CS Memorandum No. 1409

Subject: Configuration Management Board Meeting No. 119

CMB Meeting Minutes #119

DATE: March 28, 2013
 MEETING DATE: **March 27, 2013**
 LOCATION: 821 Howard St, Main Conference Room
 TIME: 3:00 PM
 ATTENDEES: A. Hoe (AH), R Edwards (RE), M. Benson (MB), R. Redmond, (RR), R. Nguyen (RN), B. Kelleher(BK), E. Stassevitch (ES), B. Ward (BW), B. Lebovitz (BL), L. Zurinaga (LZ)
 COPIES TO: Attendees: S. Farhangi (SF), J Funghi (JF), A. Wong (AW), J. Park (JP), S. Wilson (SW), M. Latch (ML), J. Wang (JW), A. Read (AR), D. Kuehn (DK)
 REFERENCE: Project No. M544.1, Contract No. 149 Task 1-8.02
 Final Design
 SUBJECT: Configuration Management Board Meeting # 119 – Rev. No. 0

TBM LOWERING
Barnhart
Gantry System Layout

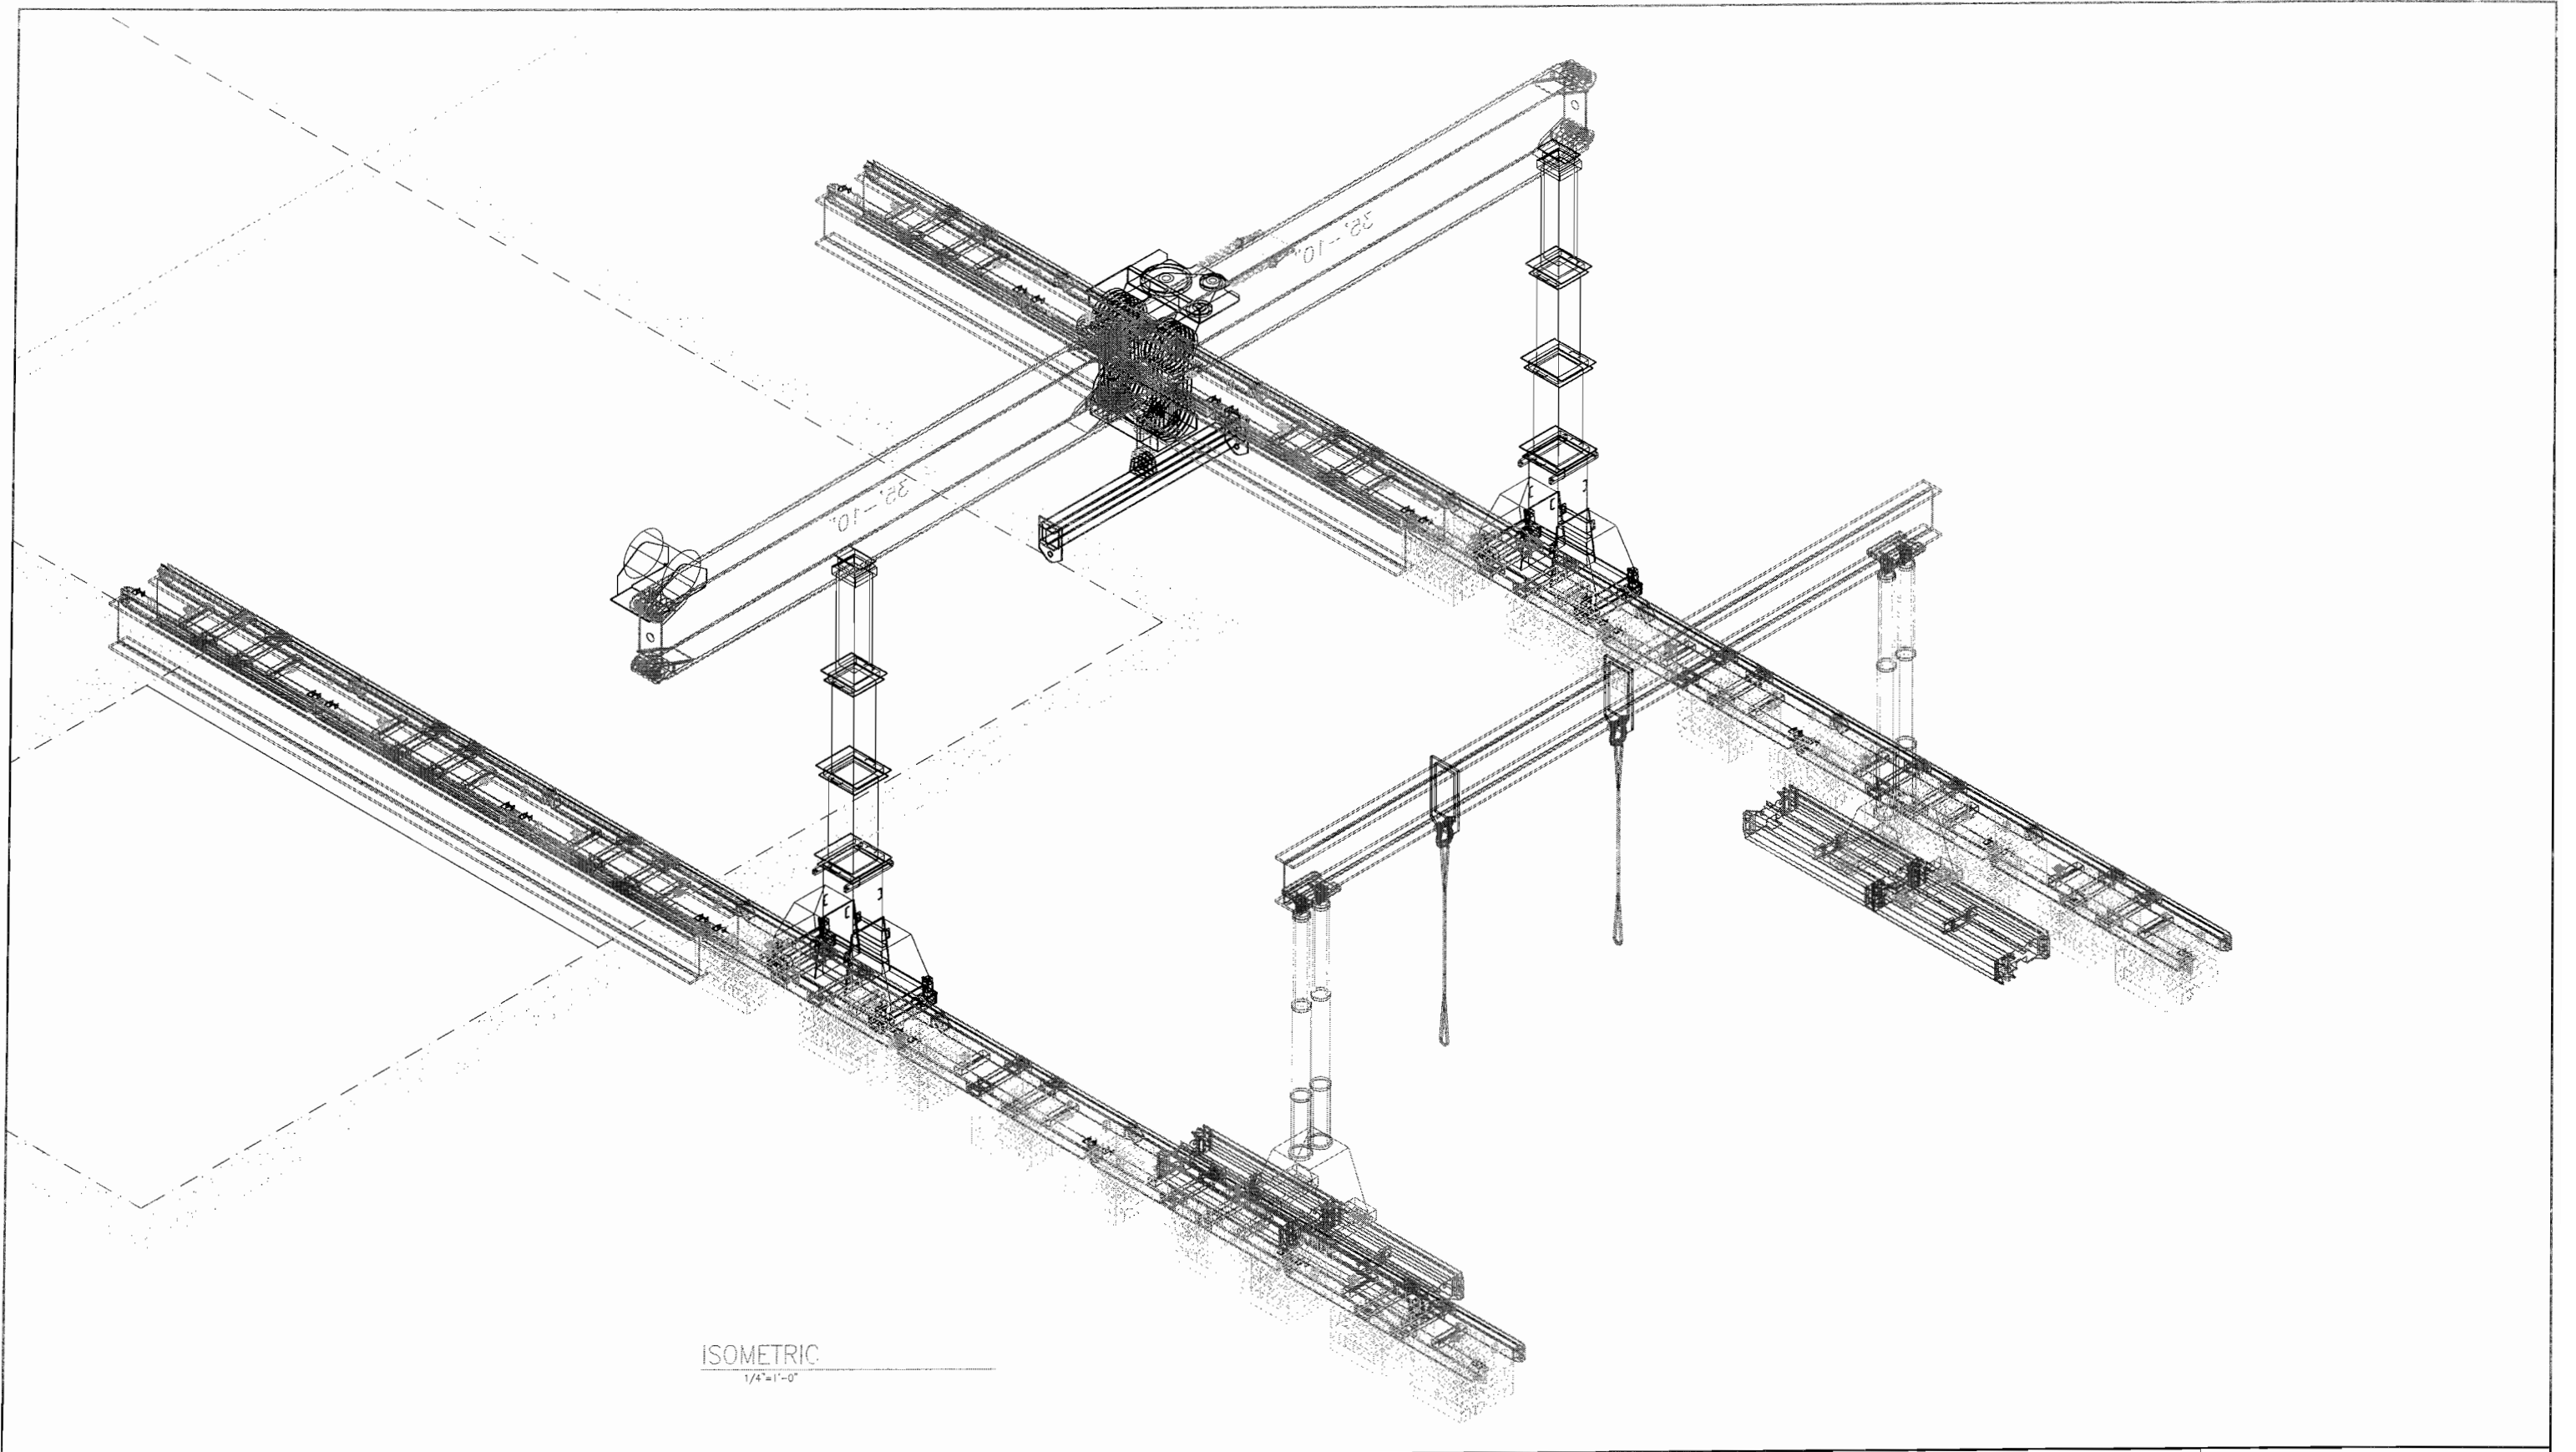
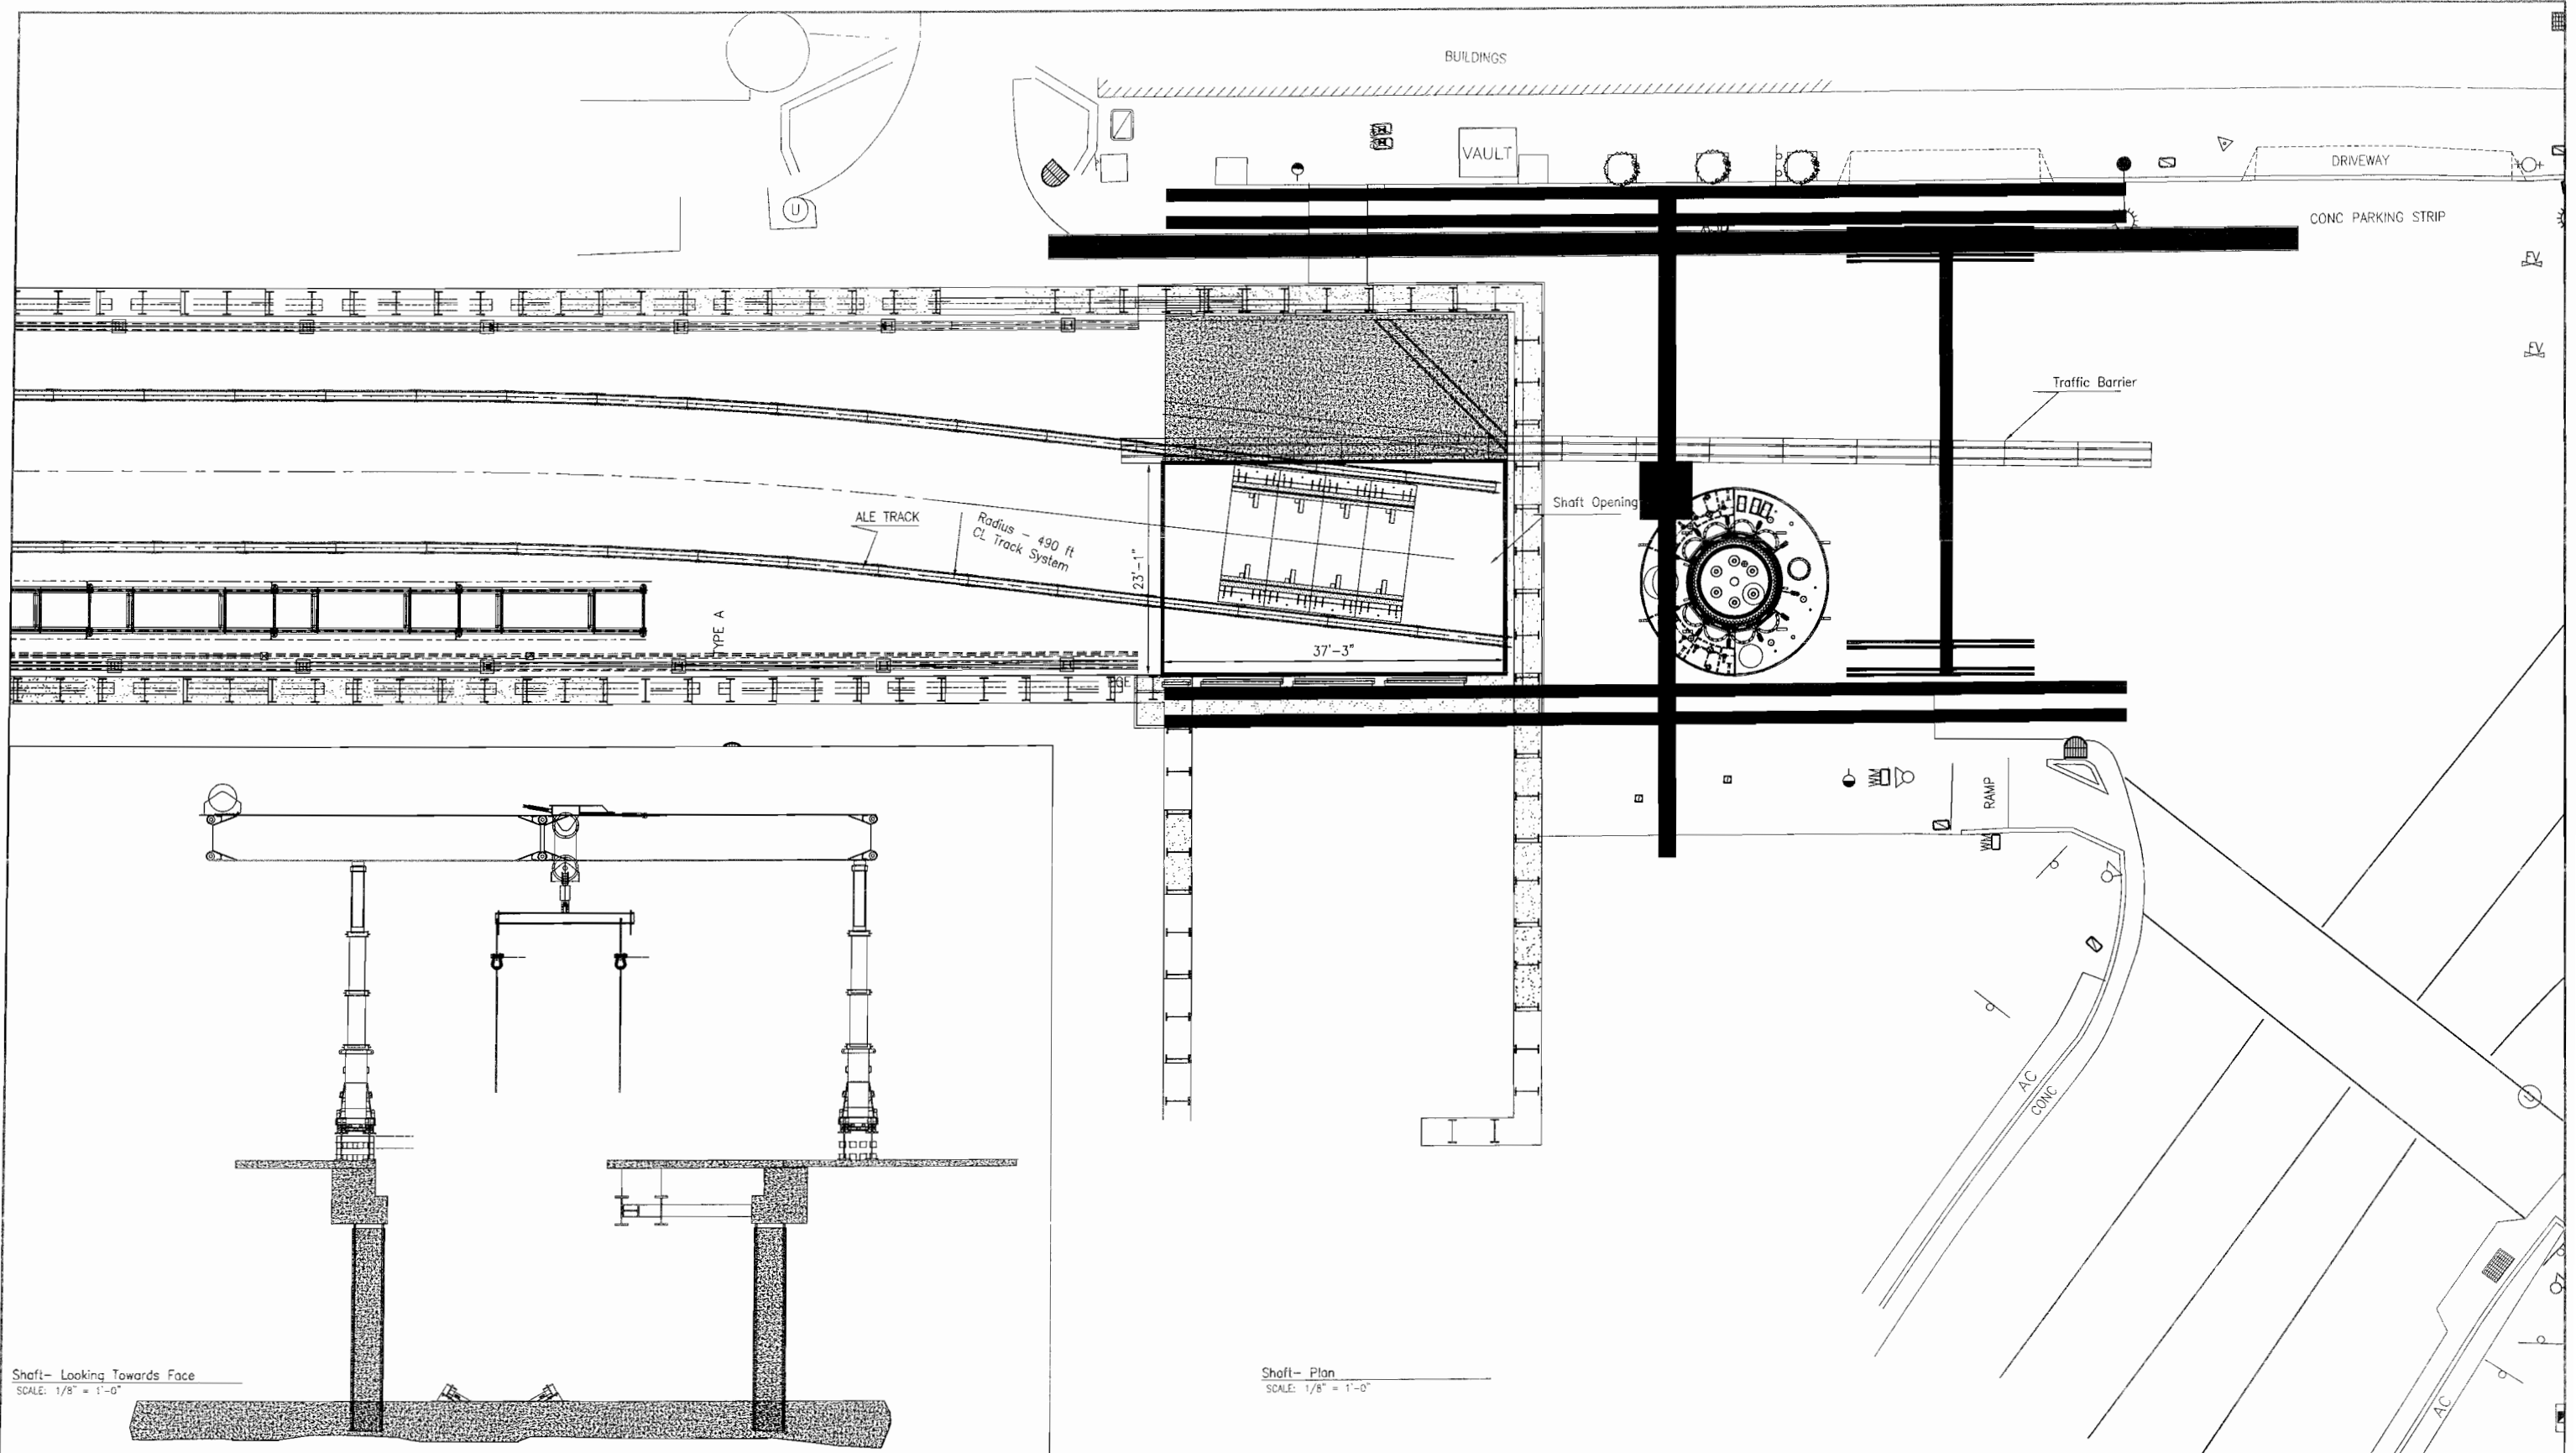
ITEM #	DISCUSSION	ACTION BY DUE DATE
1-	<p>1252 - Tunnel Boring Machine (TBM) Assembly Submittal – R. Redmond presented for review TBM assembly submittal from the Contractor. Review of the submittal by the CMB suggested the submittal response be Revise and Resubmit with the following bullet points be addressed with resubmittal:</p> <ul style="list-style-type: none"> • Must have 11ft lanes per the Contract specs • Means and Methods must comply with all contract requirements • Need the deck redesign <ul style="list-style-type: none"> ○ How will it be done ○ Timing (weekends) • Gantry Crane <ul style="list-style-type: none"> ○ No specs on its capacity - crane safety checklist ○ How close do trucks that back up under the gantry to unload affect the highway off ramp ○ How is the public protected , fence between sidewalk by Speedway and the gantry track ○ What load is applied to the road under the gantry rail dunnage <ul style="list-style-type: none"> ▪ new sewer runs under the gantry crane track ○ CalTrans must approve its use as it is so close to the highway <ul style="list-style-type: none"> ▪ Visual and aerial easement ▪ Operating too close to the highway?? ○ Is the gantry crane demobilized after the 1st TBM installation • A L E moving system for the TBM <ul style="list-style-type: none"> ○ safety plan ○ any design calcs required • Schedule duration can't be evaluated properly (due to pdf redaction) • Field office should review for all contract requirements
